Access Compliance Report Public Rights-of-Way (Curb Ramps)

Main Street: CROWN_VALLEY_PKWY Cross Street: SIENNA_PKWY Location: N

ADA ID: RPRK211101114146 Ramp Type: Type 1 - Perpendicular Diagonal Initial Pass/Fail: Fail Overall Compliance: No Severity Score: 15

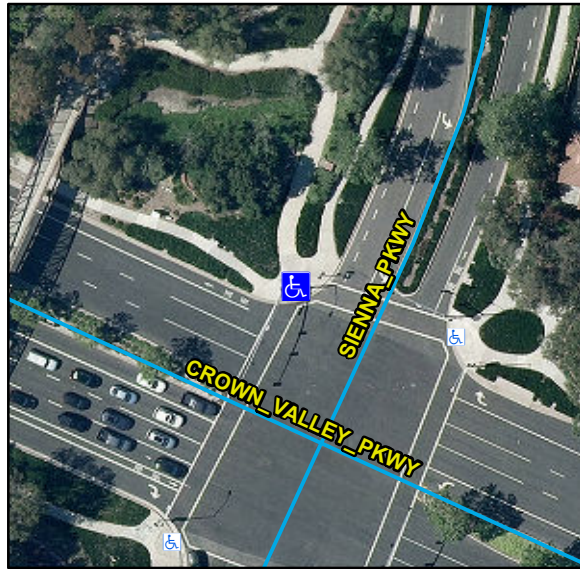
R304.2.2, R204.3, STD 1115

Remove & Replace Curb Ramp With Two New Directional Ramps or Equivalent.
